REMARKS

This is a full and timely response to the outstanding non-final Office Action mailed March 29, 2005. Through this response, claims 1, 2, 5-8, 15-20, 25-27, and 31 have been amended. Further, it is respectfully submitted that claim 20 has been amended to address the claim objections, and not for purposes related to patentability. Also, it is respectfully submitted that no new matter has been added. Reconsideration and allowance of the application and pending claims 1-31 are respectfully requested.

FIG. 2

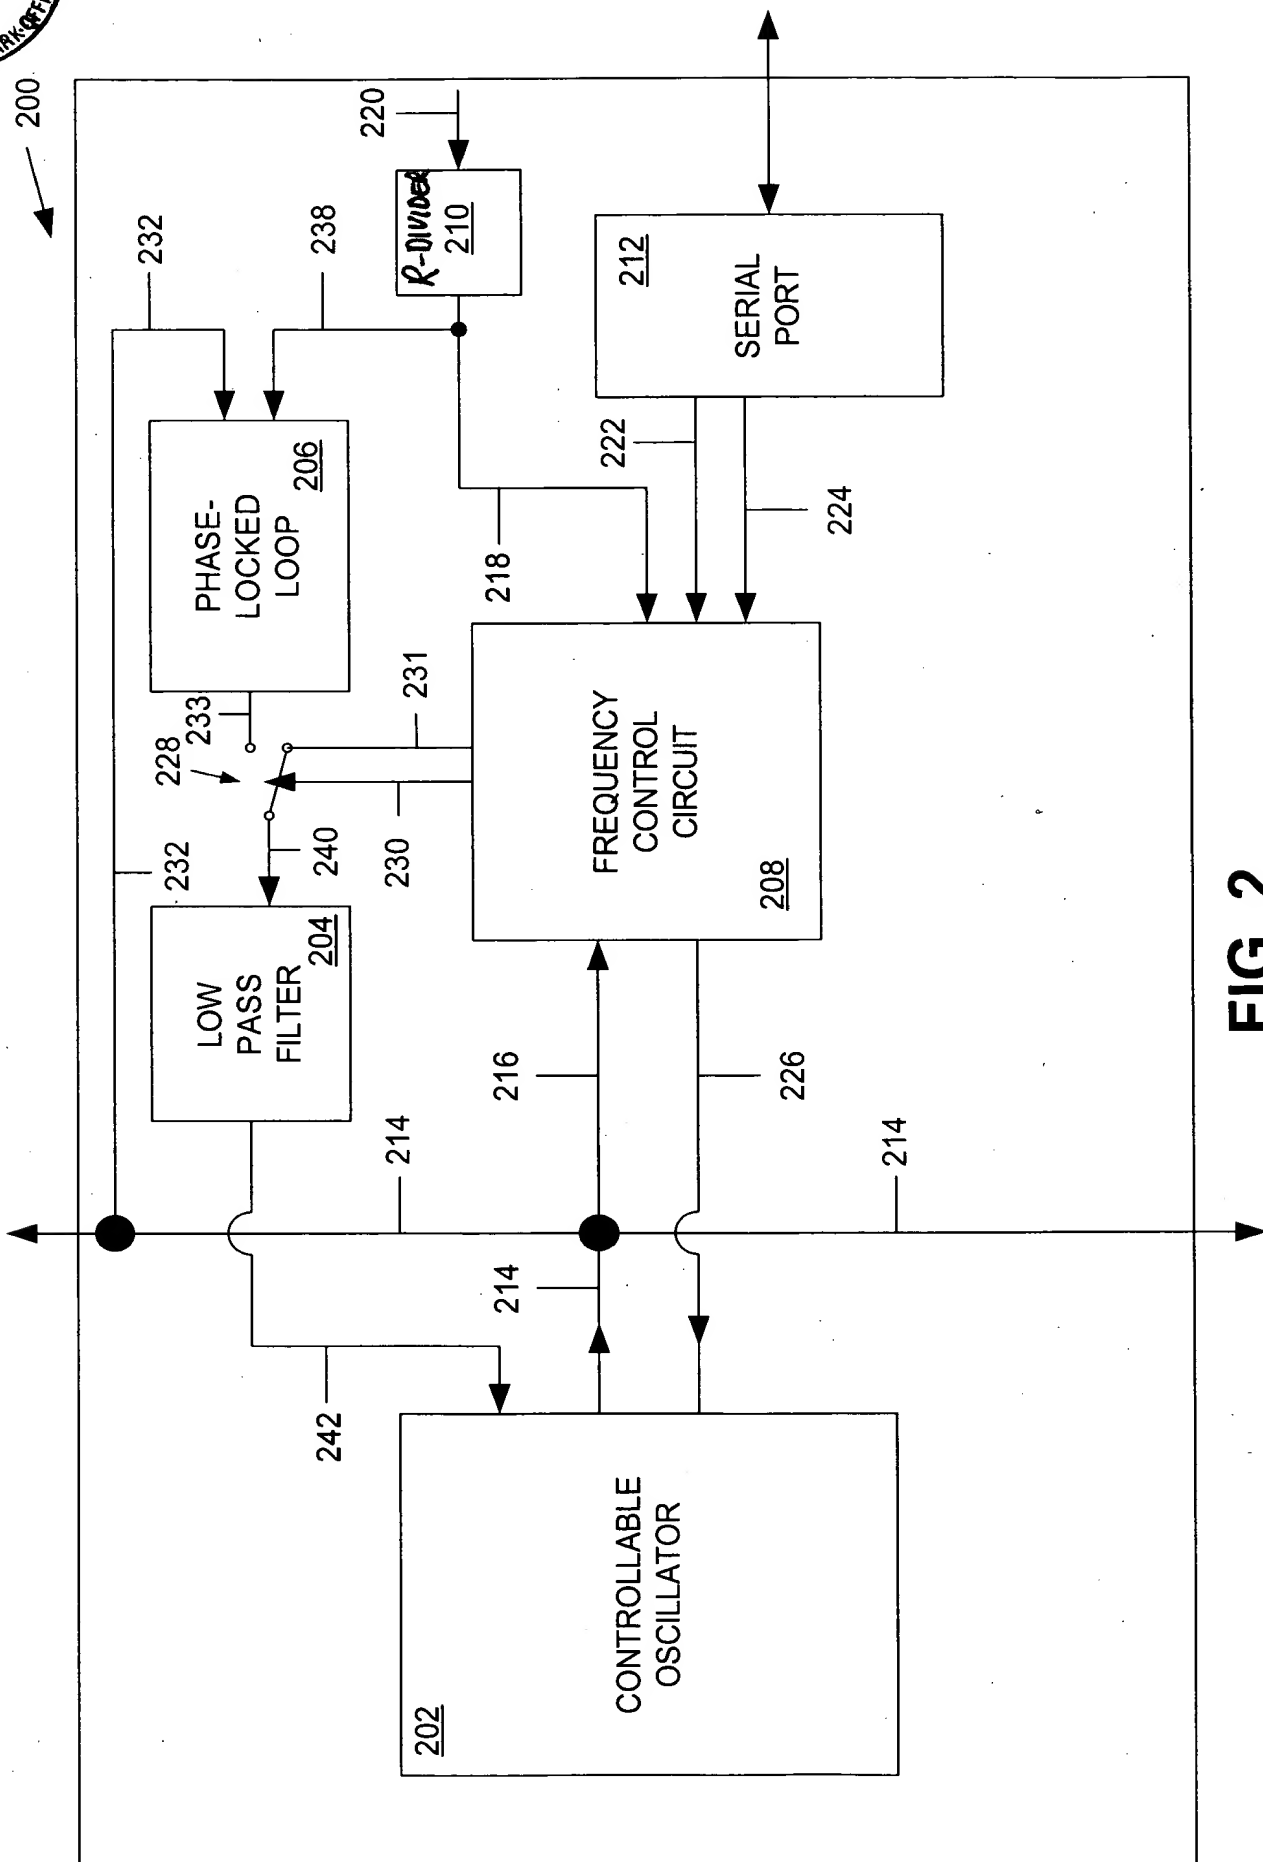
The drawings are objected to because the block pertaining element (210) in both Figure 2 and Figure 8 needs to have descriptive label, in conformance with 37 CFR 1.84(n) and 1.84(o). For example, a descriptive label of "R-DIVIDER" should be inserted into Figures 2 and 8 to properly describe element (210).

In response to the objection, the drawings have been amended to include a descriptive label in block element 210 of Figures 2 and 8 as suggested by the Examiner. A clean copy of Figures 2 and 8 and a marked-up copy of the same that shows all changes in red ink have been included with this Response. It is asserted that no new matter has been added. Applicants respectfully submit that the drawing objections have been overcome, and respectfully request that the objection be withdrawn.

Please replace Figures 2 and 8 with newly submitted figures attached herewith on separate sheets. Applicants have included marked-up sheets showing the amendments made to the figures.
